Technical Bulletin

Subject: Transmission Case, Sealing

Number: 97-06

Model(s): All with 020 transmission

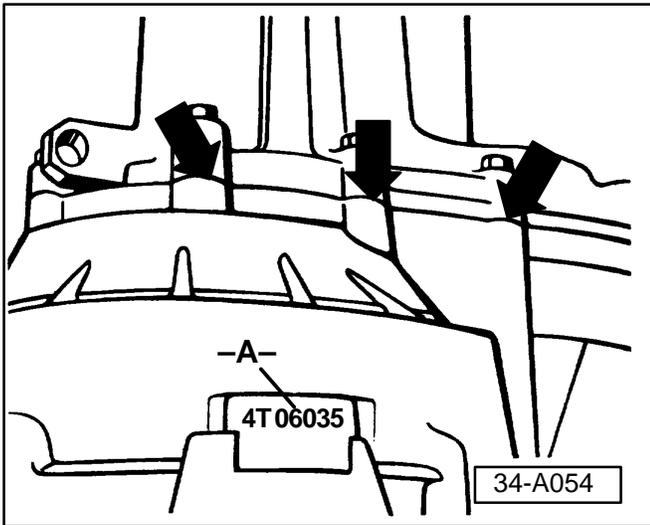
As of transmission build date 06035, Most transmission cases have been sealed using sealant AMV188 200 03 instead of a paper gasket between case halves at -arrows-.

Code letters and date of manufacture -A-.

Pre-load adjustment on bearings will be affected if correct sealing method is not used.

DO NOT install a paper gasket when a transmission has been sealed with sealant.

DO NOT use sealant AMV188 200 03 on transmission that has been sealed with a paper gasket.
